CORRIGENDUM - 03 TO NIT NO-73129

Subject: Corrigendum-03 to Tender enquiry for Supply & Services of 220 kV GIS FOR OPTCL ERSAMA, PARADEEP PROJECT.

Project : OPTCL ERSAMA, PARADEEP Project
Equipment / Item : SUPPLY & SERVICES OF 220kV GIS.
Enquiry No/Date : Enquiry No_61G2300343 dtd 05-04-2023
BHEL NIT NO : 73129
Original Tender due date : 27.04.2023

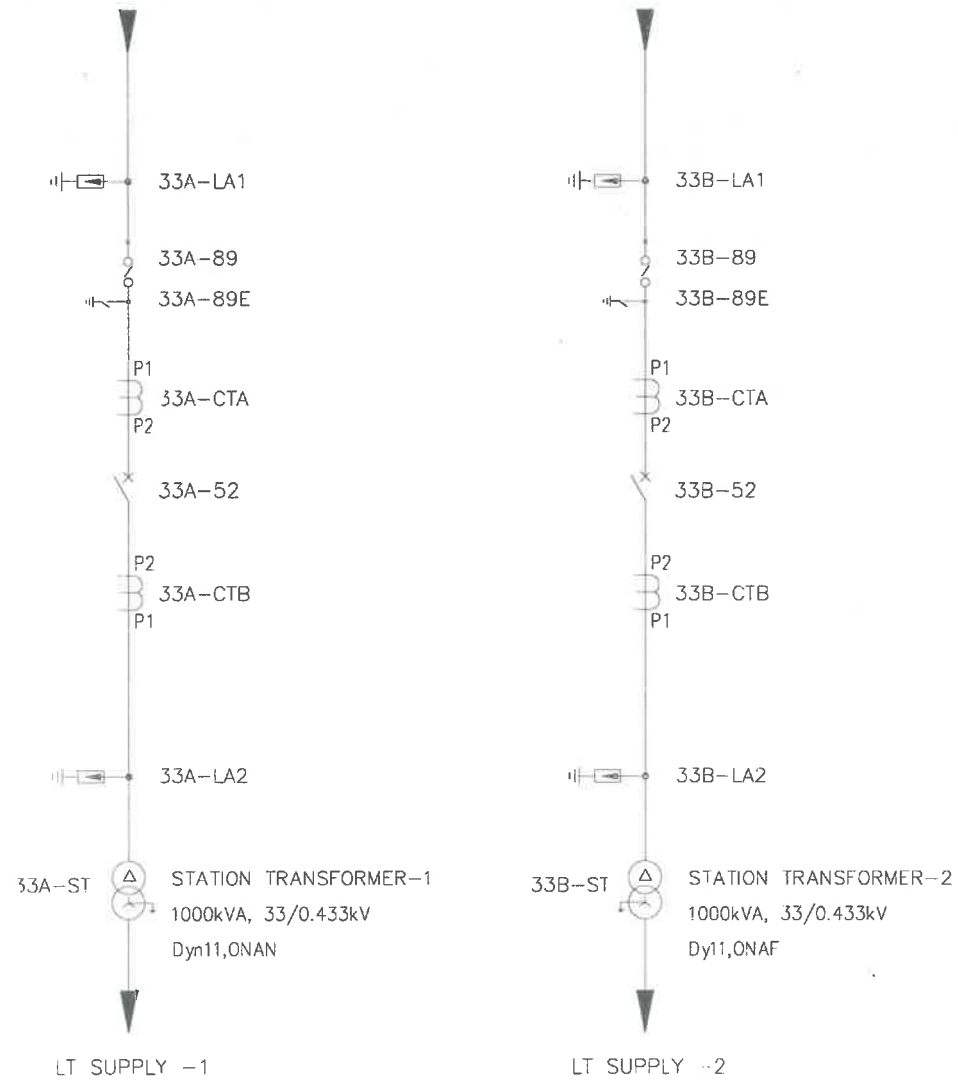
LT SUPPLY SOURCE -1 & 2: 33kV SIDE OF STATION TRANSFORMERS-1 & 2 ARE TO BE FED THROUGH TERTIARY LOADING OF ICT#1 & ICT#2. FURTHER, AS PER THE REPLY TO PRE-BID QUERY OF PKG-36(1)/2020-21, PROVIDED BY OPTCL IN ADDENDUM-2, EQUIPMENT WITH HIGHEST SYSTEM VOLTAGE OF 36kV ARE BEING PROVIDED IN THIS CIRCUIT.

As per tender condition complete design & engineering is on the scope of M/s BHEL, hence 30kV equipment is to be supplied as per detail of Let tertiary Bushing.
